Application No.: 10/765,494
Amendment Dated: October 6, 2005
Reply to the Office Action of July 6, 2005

Remarks/Arguments

FIGURE 1

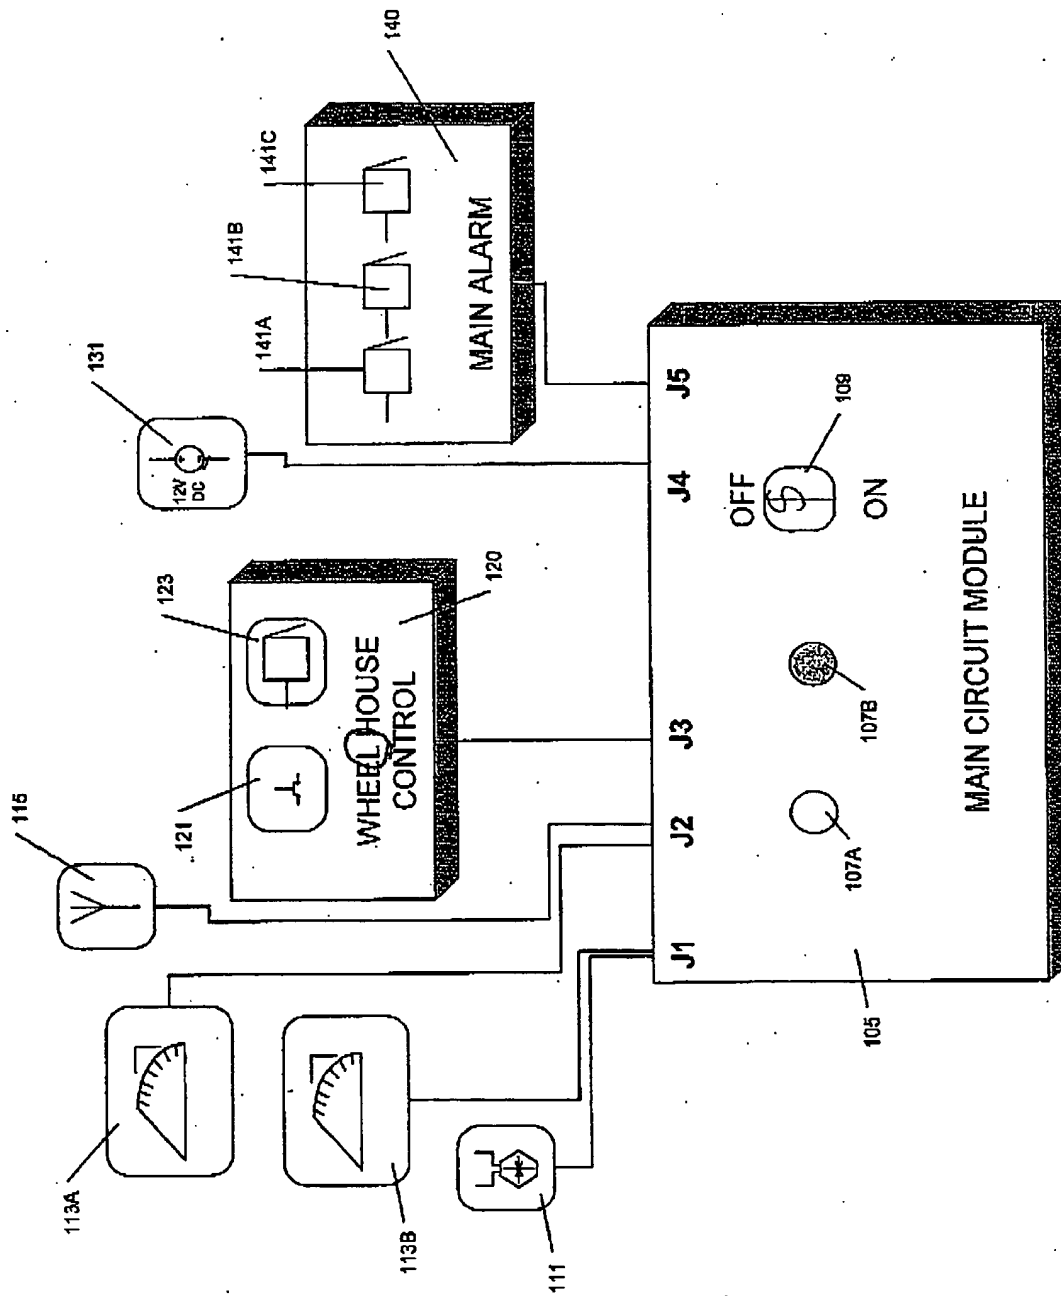
Fig. 1 is objected to because block 120 states "WHEE LHOUSE." Replacement Fig. 1 states to "WHEEL HOUSE."

FIGURE 2

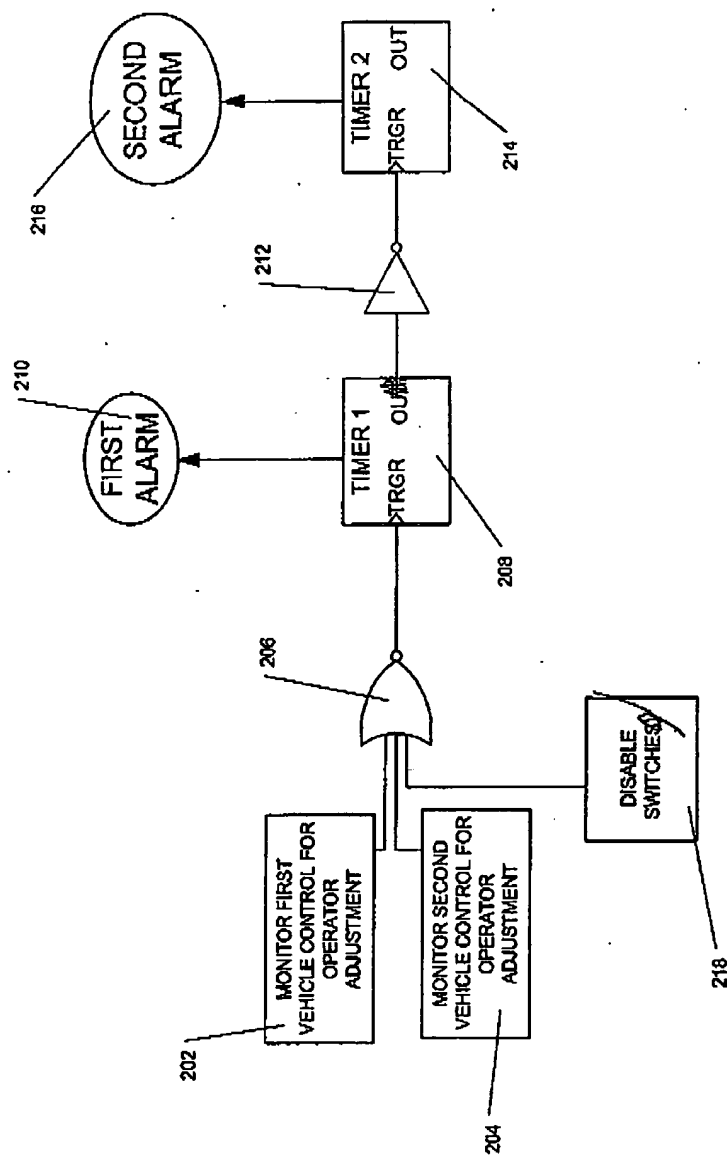
Fig. 2 is amended to remove a superfluous right parenthesis from block 218 and to remove a portion of a line that extends into the word "OUT" in box 208.
